AGENCY:	City Council
MEETING DATE:	March 23, 2015
DEPARTMENT:	CDD
PRESENTED BY:	Marie Jones

**RECEIVE REPORT, CONDUCT PUBLIC HEARING AND PROVIDE DIRECTION TO STAFF REGARDING: 1) APPEAL BY EDWARD OBERWEISER, ET AL. OF THE PLANNING COMMISSION'S JANUARY 28, 2015 DECISION TO APPROVE A MITIGATED NEGATIVE DECLARATION FOR THE HARE CREEK CENTER PROJECT; LOCATION: 1250 DEL MAR DRIVE, FORT BRAGG; AND 2) APPEAL BY GROUP II REAL ESTATE OF THE PLANNING COMMISSION'S JANUARY 28, 2015 DECISION TO DENY DEVELOPMENT PERMITS FOR THE PROPOSED HARE CREEK CENTER PROJECT AT 1250 DEL MAR DRIVE (CDP 8-13, DR 7-13, USP 5-13 AND LLA 3-14)**

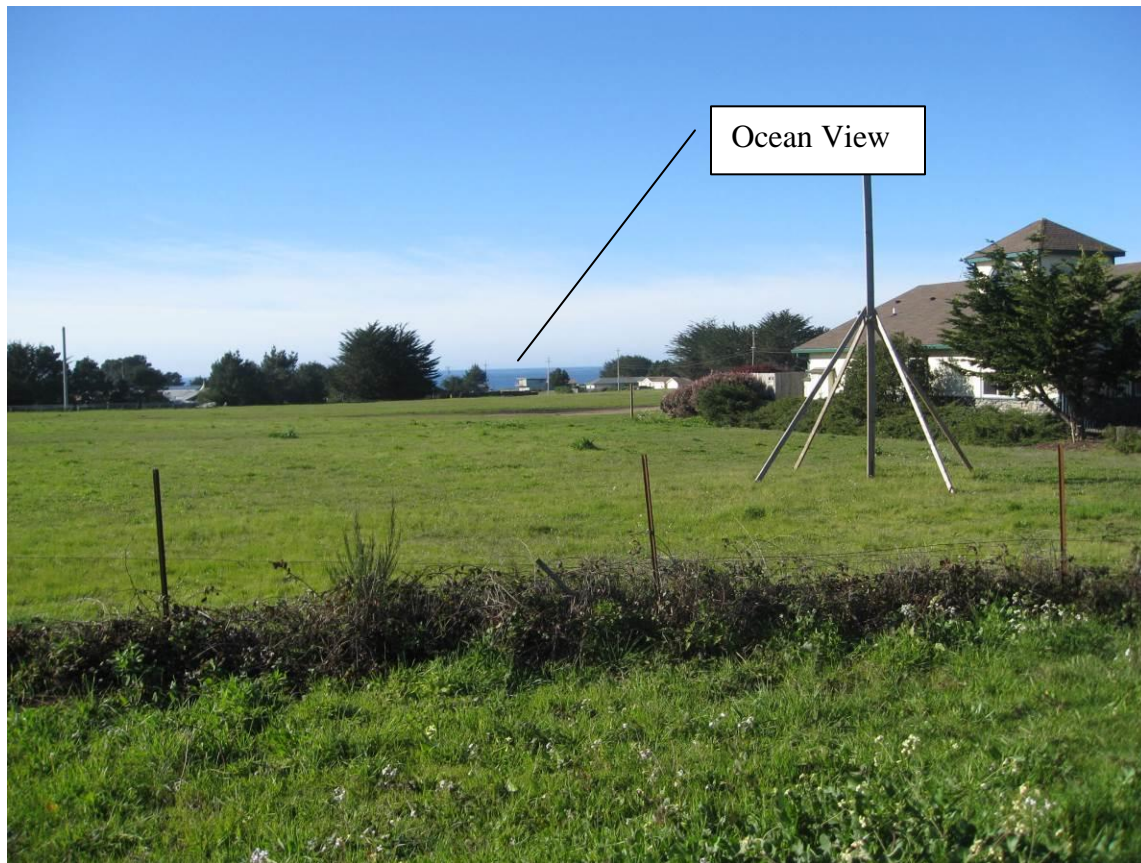
**j) Possible visual impact of the project on partial ocean views.**

As noted on page 6 of the MND, the review authority must make a finding that the project is sited and designed to protect views to and along the ocean and scenic coastal areas. This issue was not

addressed in the MND. A filtered distant view to the ocean is visible from Main Street, if one looks directly to the west at the top 50 feet of the site. Please see the photo below.

*Staff recommends that a revised CEQA document address this issue.*

## Historic Façade Design Alternative

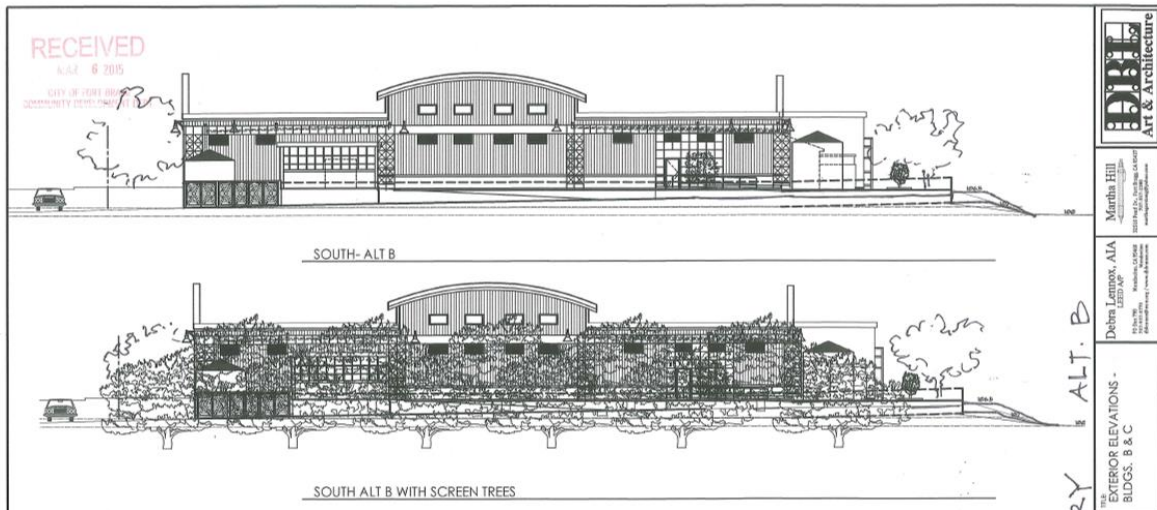
If the City Council chooses to approve the design review permit, staff recommends the the Historic Façade Design Alternative, as it conforms more with the historic character of the City of Fort Bragg. Additionally, this design alternative provides more architectural detailing on the false front of the building than the current proposed design. Staff further recommends that this level of design detailing be added to the eastern face of Building C, which fronts Main Street (see special condition 2 below). If City Council prefers some other design approach, direction should be provided to staff.

**Figure 1: Vacant Retail and Office Space in Downtown Fort Bragg.**

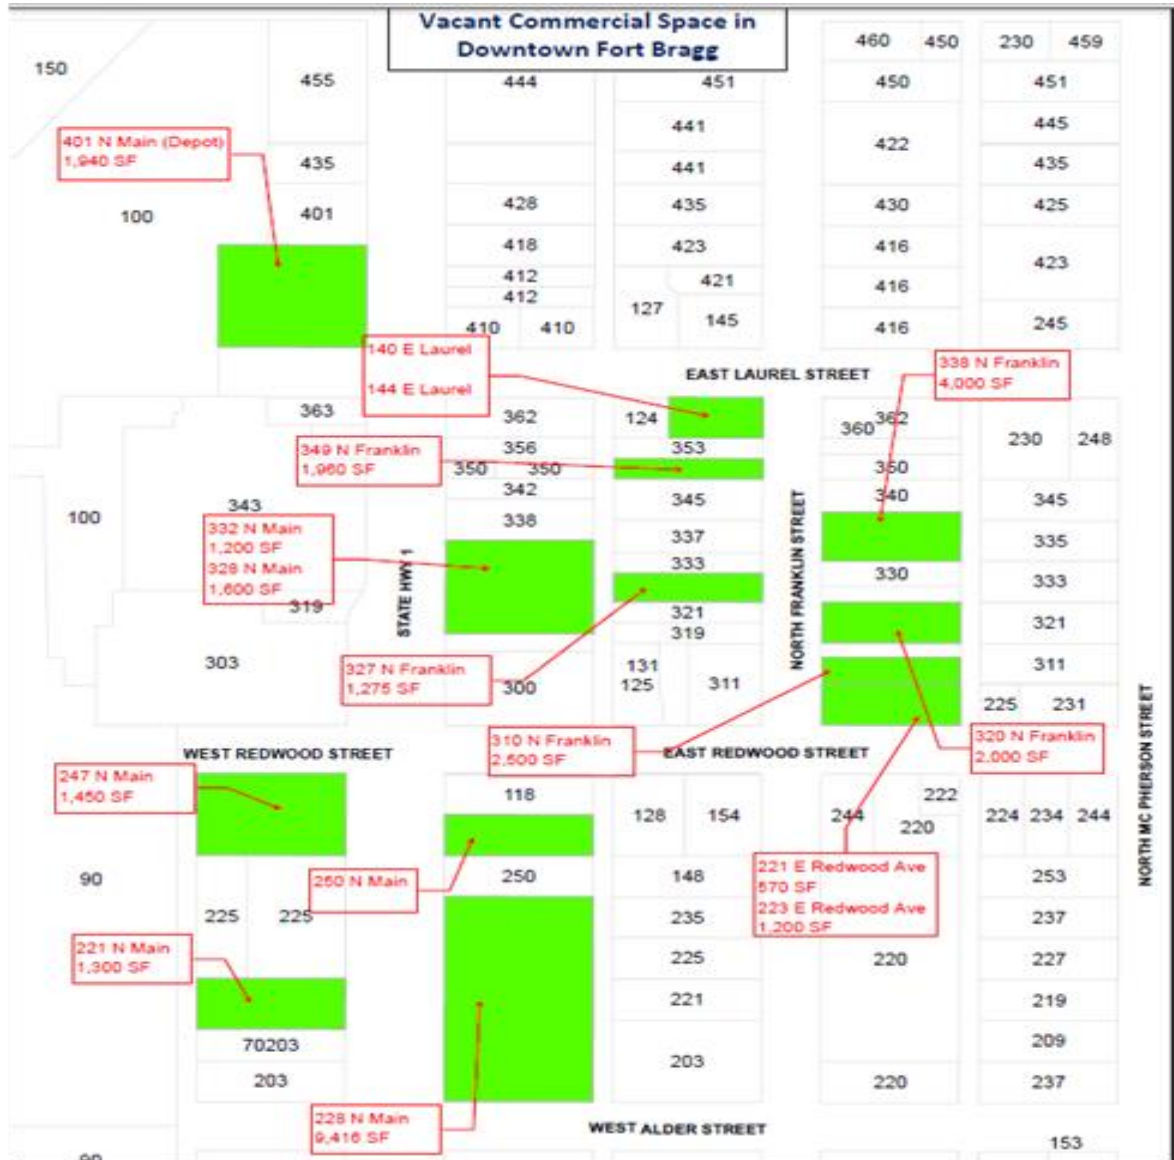
As shown in Figure 1, there are 13 vacant storefronts in Downtown Fort Bragg which together total about 30,000 SF of vacant space. Two of these spaces (totaling 3,000 SF) are leased and will be occupied within the next two months. The old BofA building is the largest vacant space at 9,000 SF and is an office space and so would not be impacted in terms of leasability by the opening of the Hare Creek Center. Thus there is 18,000 SF of vacant retail space in downtown Fort Bragg, which is about 4% of all retail space in the downtown (estimated at 440,000 SF). This 18,000 SF of retail space might be slower to lease due to the Hare Creek Center. The Hare Creek Center would add 4,500 SF of small tenant retail space that would compete with the 19,000 SF of vacant space in the downtown for some types of tenants. Thus the Hare Creek Center could have a minimal impact on the rate that vacant space is leased in downtown.

Based on the evidence presented herein, the project is not expected to result in indirect physical changes to the downtown, and more specifically would not result in urban decay. However, should Council direct staff to revise the environmental document, this analysis would be included.
